From: Sent: To: Cc: Subject: Chavez, Carl J, EMNRD Thursday, June 16, 2011 11:19 AM 'Moore, Darrell'; Cobrain, Dave, NMENV Monzeglio, Hope, NMENV RE: NRS Detailed Area Piping Plan Drawings

The OCD is in receipt of the engineering pipeline drawings for the waste water system. The OCD approved the tank upgrades with conditions on May 3, 2011.

DISCHARGE PERMITJOW 4281 NAVAJO REFINING COMPANY PROPOSED TRACES LEAK TEST PROJECT

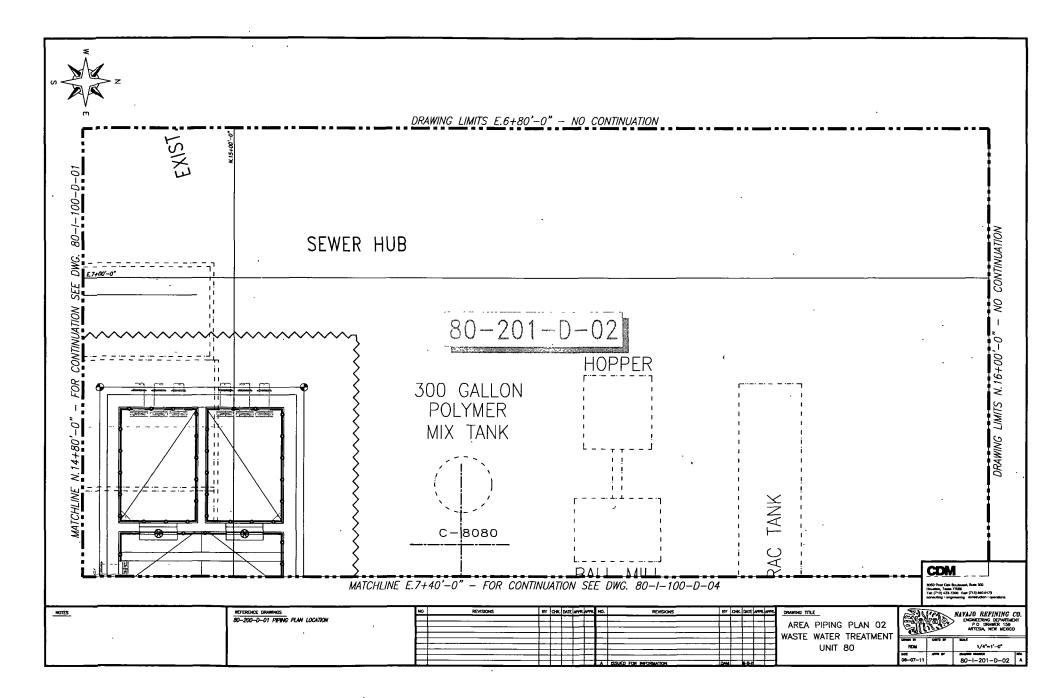
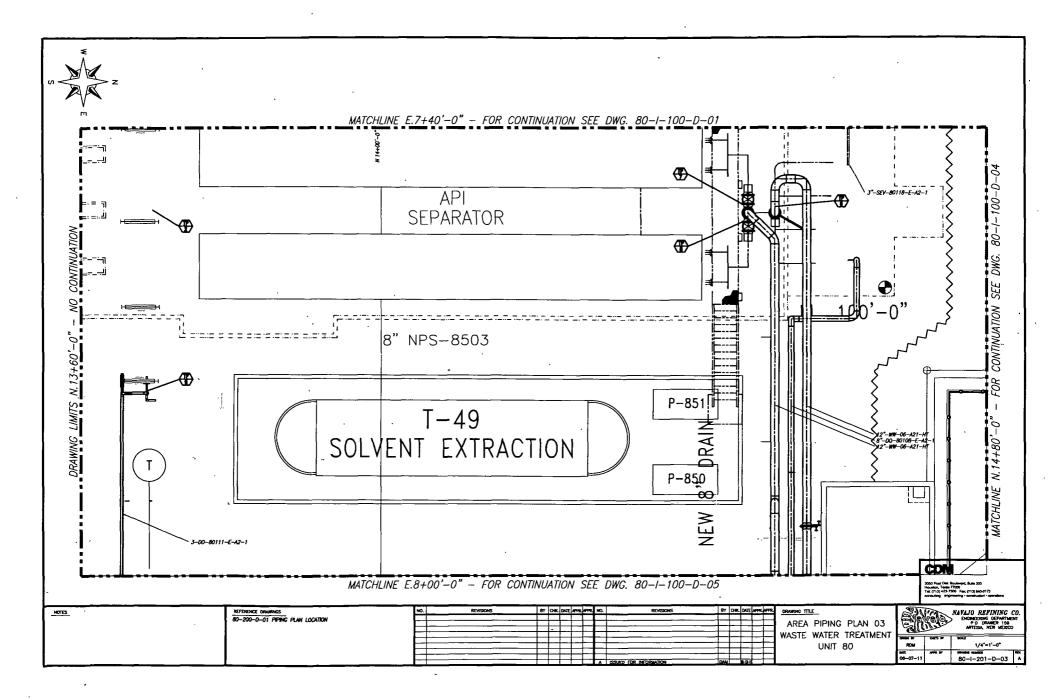
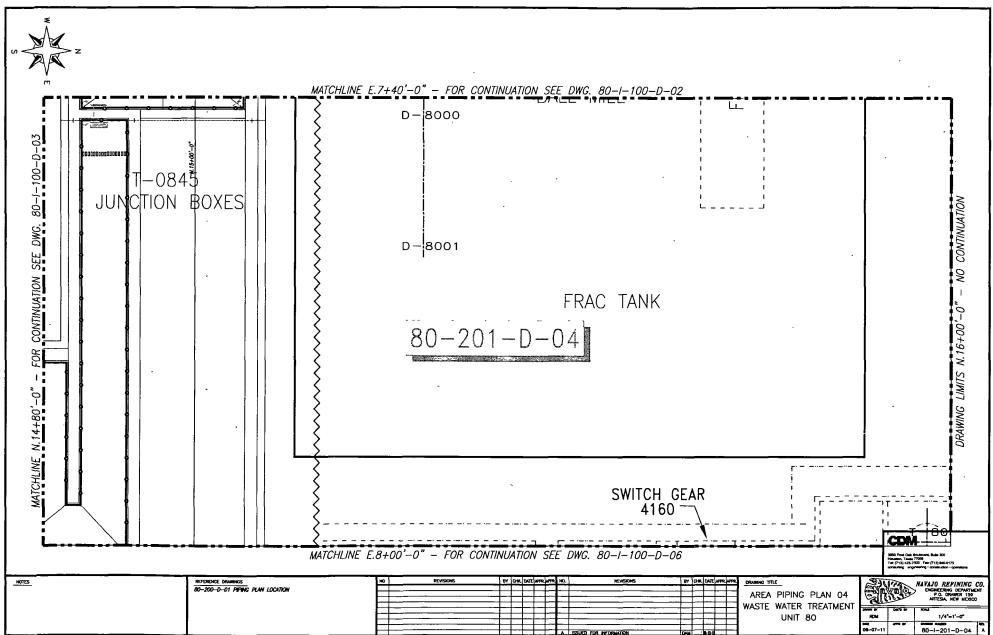
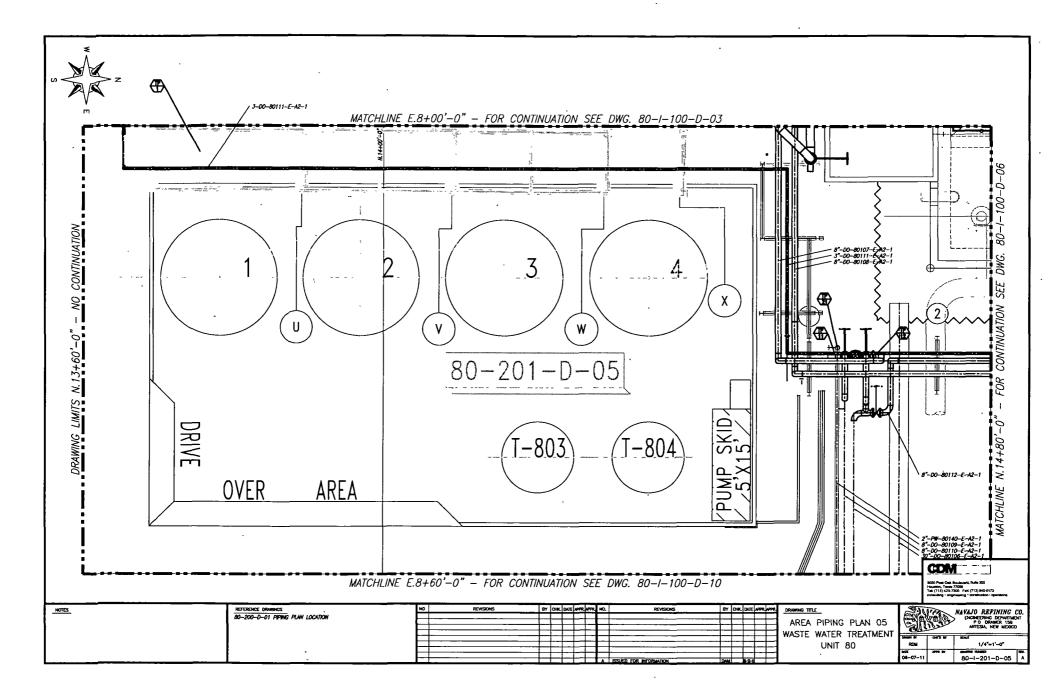
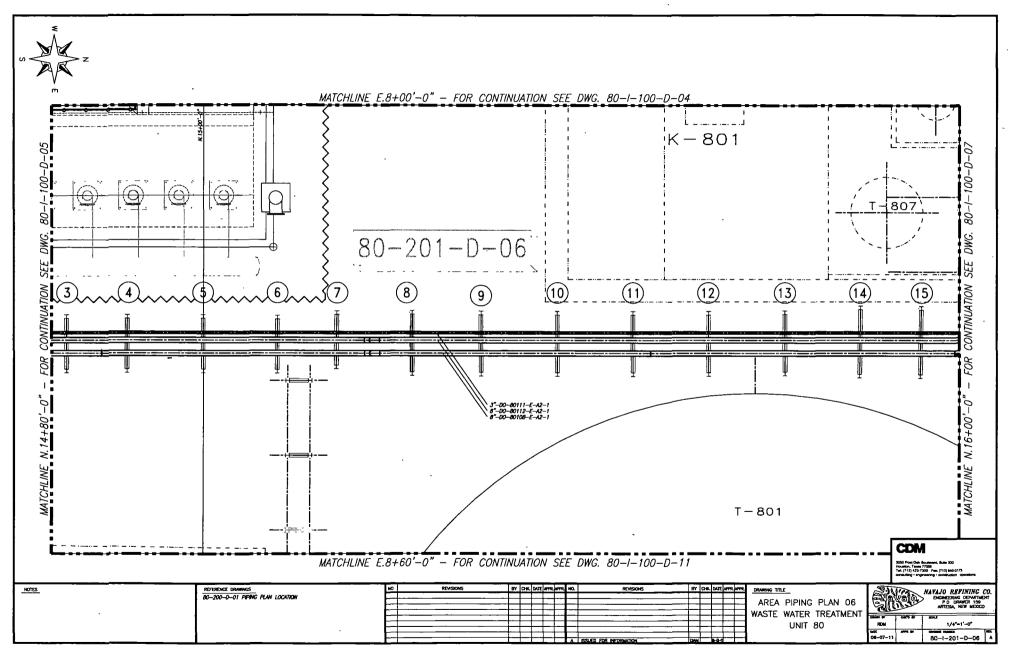
Based on the attached drawings, the new tanks appear to be: Tk-0829, Tk-836, Tk-49 (solvent extraction tank), Frac Tank (Dwg: 80-1-201-D-04), Tk-803, Tk-804, Tk-1, Tk-2, Tk-3, Tk-4, Tk-807,.....

Dwg: 80-1-201-D-02 depicts a 300 GALLON POLYMER MIX TANK, which must also meet the design and construction requirements of the permit.

OCD requests that Navajo provide the listing of all new tanks (which include Frac Tanks?) installed at the facility so the OCD can inspect the locations for compliance with the permit.
